201 & 401 Crescent Ave Map Amendment

NUMBER: PC2305-0003

KENTON COUNTY PLANNING COMMISSION
STATEMENT OF ACTION AND RECOMMENDATION

NUMBER: PC2305-0003

SITE PLAN

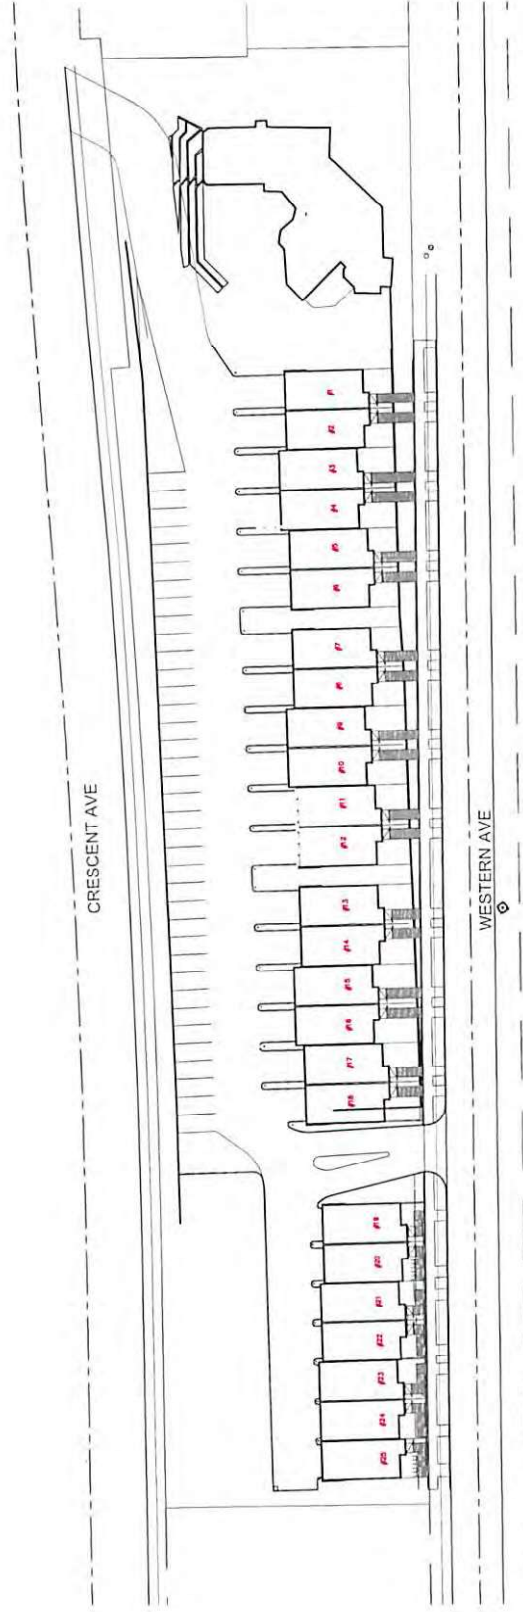
2. The submitted Stage I Development Plan meets the minimum requirements of the Covington Neighborhood Development Code, except for the following:
 - a. Section 02.04.1.C.6. sets the maximum height within the SU (Semi-Urban Residential) Character District as the greater of 35 feet or 120 percent of the context average. In this case, the nature of the subject context prescribes the maximum height as 35 feet. The proposed plan is showing a maximum height of 35 feet four inches for "Building D". The applicant is seeking a variance for this requirement.

- b. Section 02.04.1.C.6. sets the maximum front yard setback within the SU (Semi-Urban Residential) Character District as the greater of 10 feet or 120 percent of the context average. In this case, the nature of the subject context prescribes the maximum front setback as 10 feet. The proposed plan indicates front street setbacks along Western Avenue at 26 feet, two inches for "Building A", 24 feet for "Building B", 22 feet for "Building C", and 12 feet, 3 inches for "Building D". The applicant is seeking a variance for this requirement.

COVINGTON TOWNHOMES:
CROSS SECTIONS

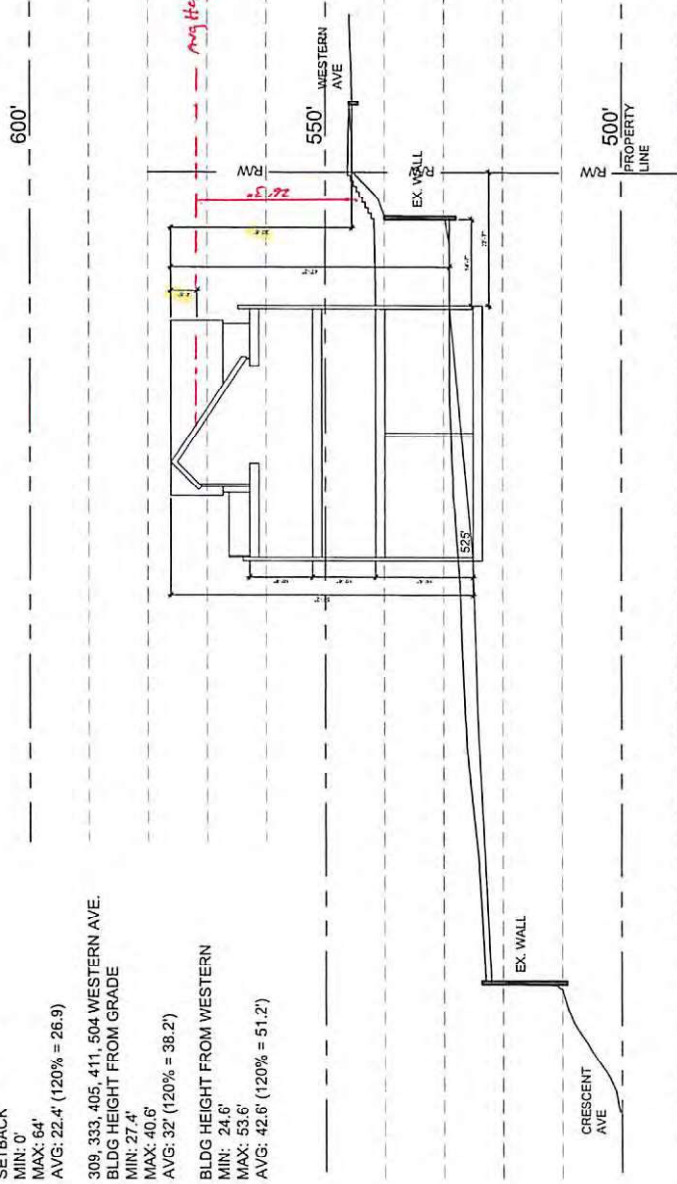
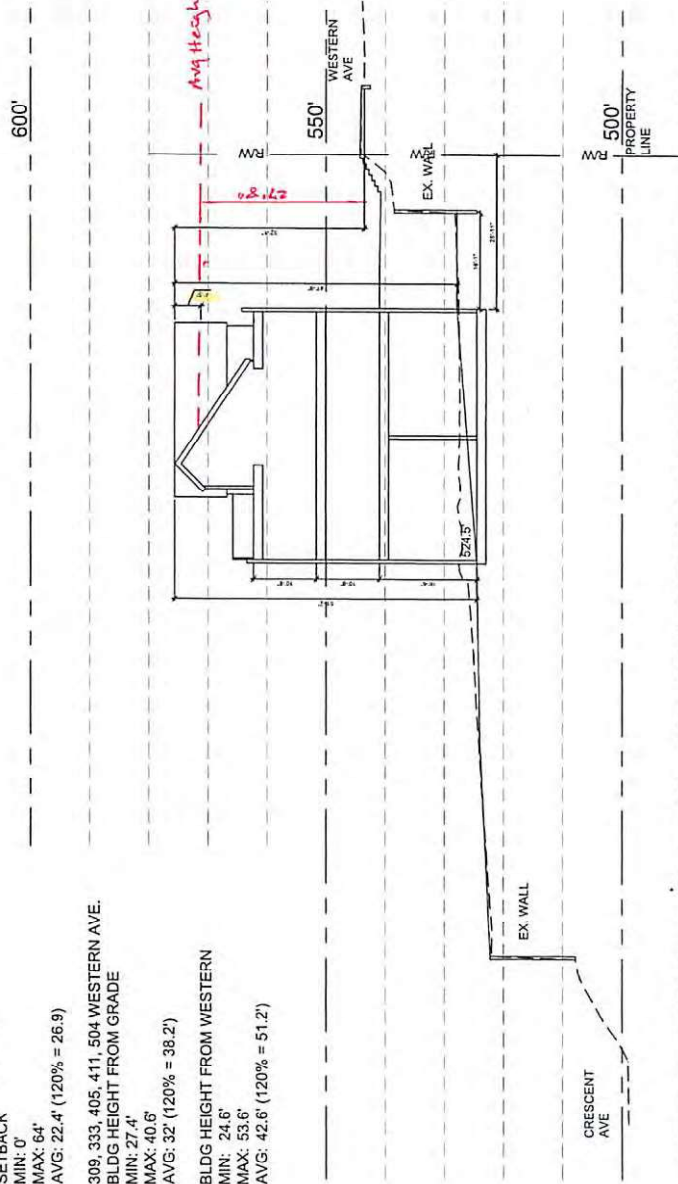
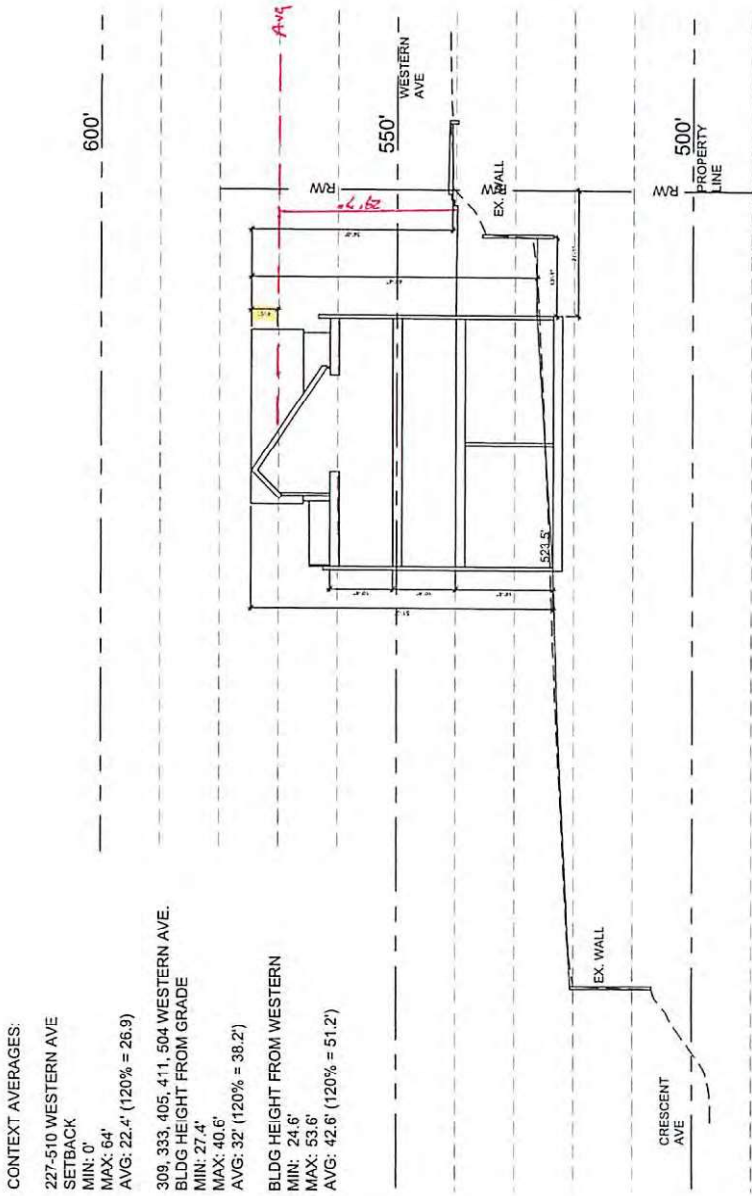
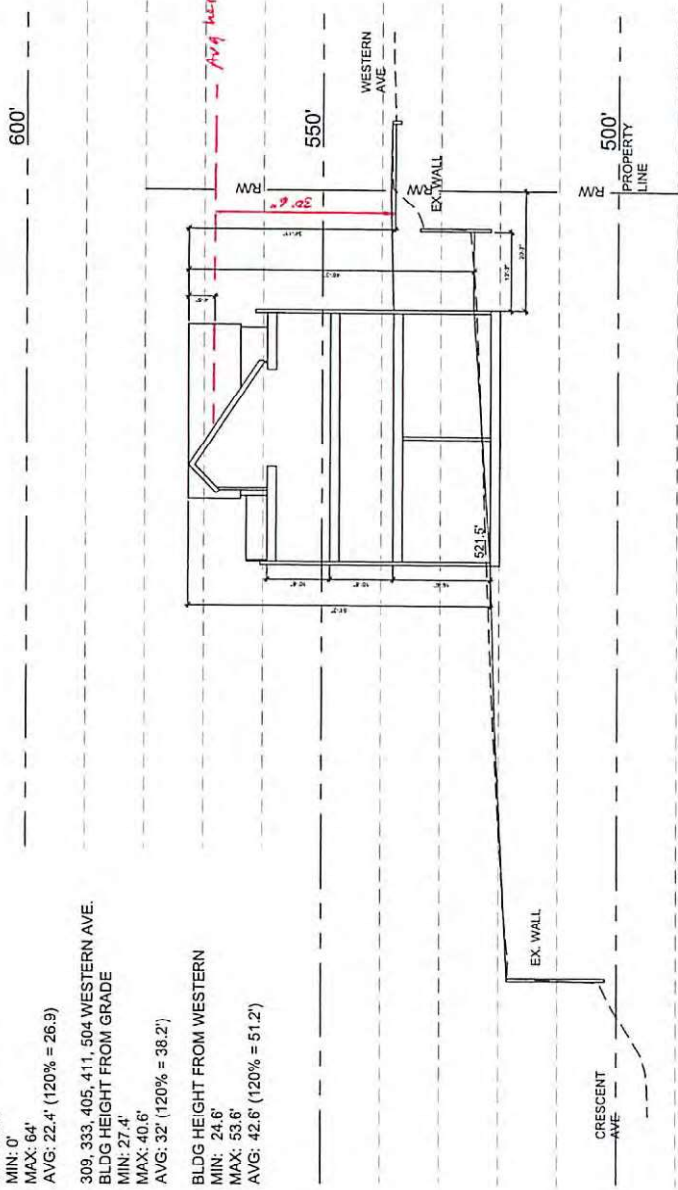
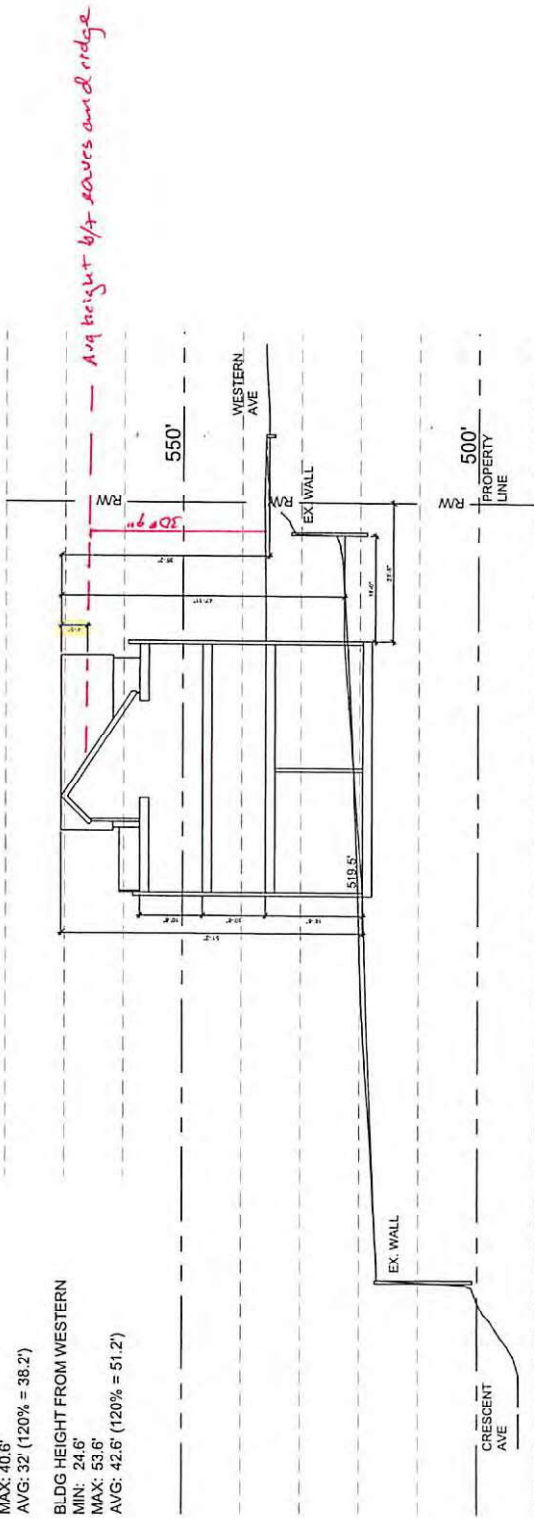
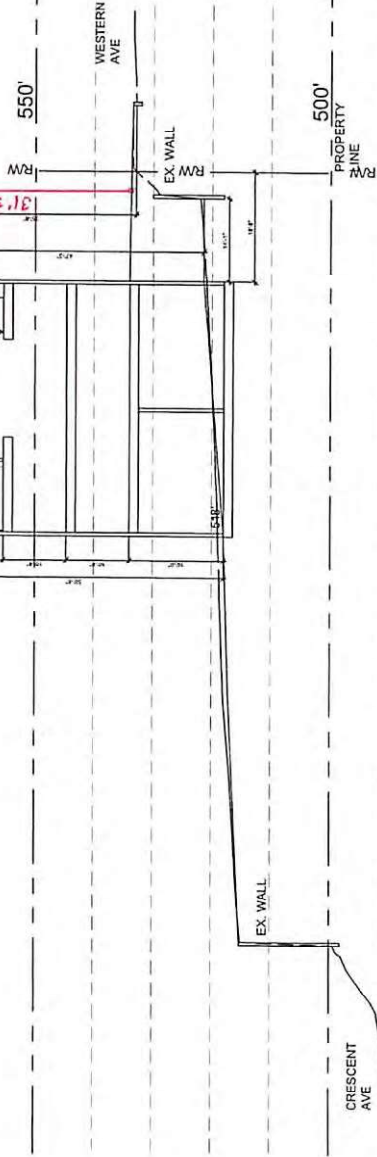
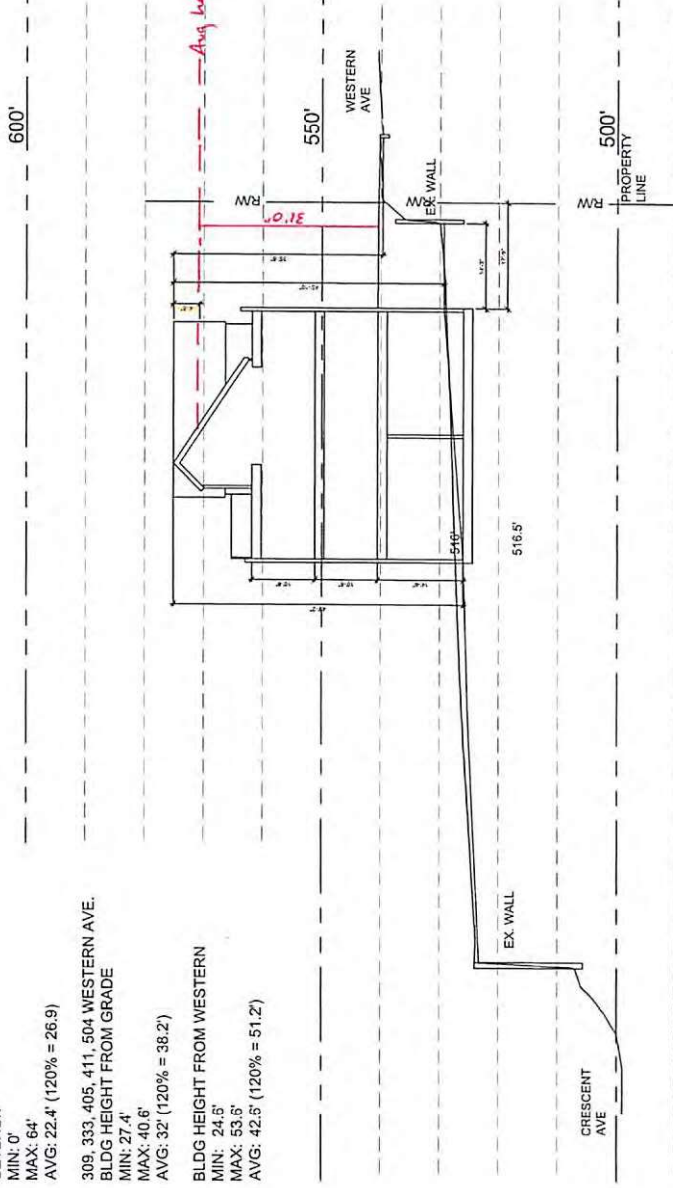
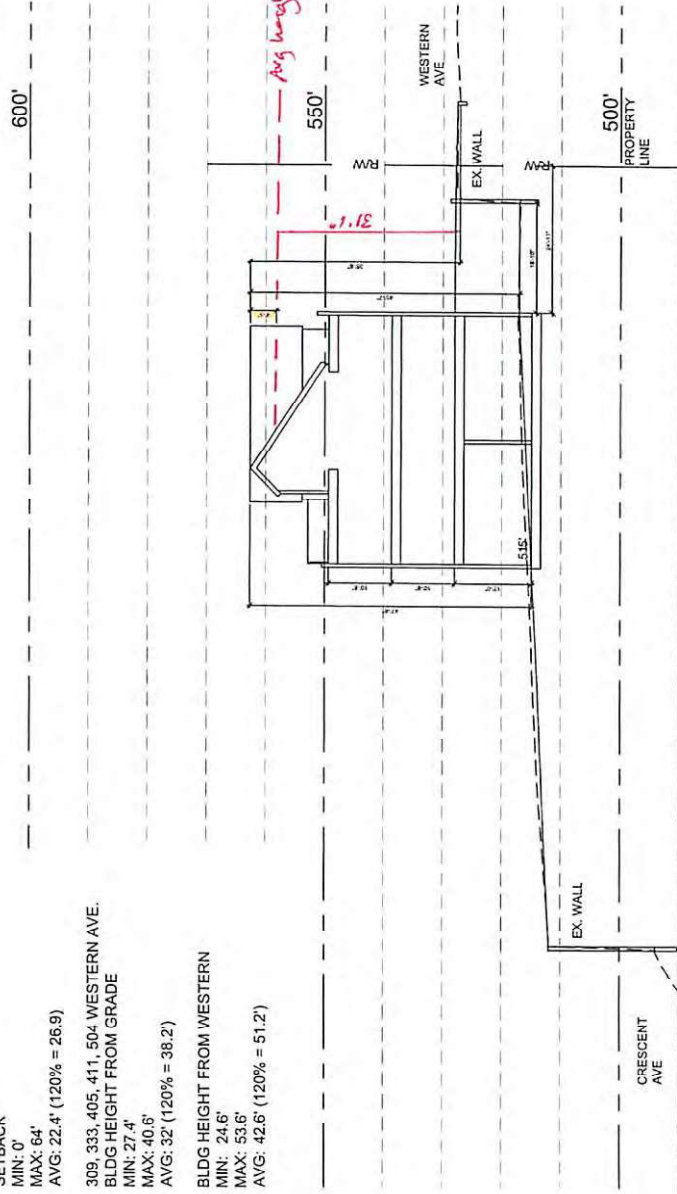
and the average height level between the eaves and the ridge is actually 4'5" lower. It is a bit confusing how that is indicated in the drawing. Also, will the 120% of context average factor into this analysis?

The average of these three numbers (for both building B & C) would be slightly over 35' if my math is correct. So, they would exceed the maximum permitted building height.

- The building height: As illustrated in Figure 09.28.1-1, Building Height, Building height is to be measured as the vertical distance measured from **average elevation of the finished grade** adjoining the building at the front of the building to:
 - The average height level between eaves and ridge for gable, hip, and gambrel roofs.
We both understand the drawing with measurements submitted; however, is this the average of all buildings height?
- Front setback varies from 16'-25' which is greater than the maximum: A variance would be needed per building for this just as a heads up.
- Please verify the side yard setbacks and their accuracy.

Per my voice messages from earlier this morning, I am following up on the emails below. In response to Dalton's email from last Thursday (May 11), I am supplementing the Cross Sections sent last Wednesday with the attached, which more clearly depicts the height of each building as defined by the NDC criteria as indicated in that email. As noted, the appropriate measurement for building height is to the "average height level between the eaves and ridge for gable, hip, and gambrel roofs". Although the original cross-sections identify this average height between the eaves and ridge as being 4'5" below the ridge, the specific height noted on those cross-sections was taken from the ridge of the roof. The attached drawings and the chart below better demonstrates the height per the language of the NDC. Measuring the height based on the average between eaves and ridge (as opposed to the peak of the ridge), the heights the relevant average height for Building A is 27'10" (from 32'3"), Building B is 30'10" (from 35'3"), Building C is 30' 8" (from 35'1") and Building D is 35'4" (from 39'9"). Building D still exceeds 35' (assuming this height limit is not adjusted per the context).

With regard to the setbacks, the cross-sections does provide the results of our study of the context averages in the immediate vicinity. To define the context we used the properties immediately across Western Avenue from 201 and 401 Crescent Avenue. The existence and location of the extensive retaining wall limits the ability to strictly comply with the setback requirements as set forth in Table 04.10.2, which states that the maximum setback is the greater of 10' or 120% of the context average. As noted below, the average setbacks from R/W for Buildings A, B and C range from 19'8" to 25'3". However, based on our study of the "context" of the properties closest to this project, the
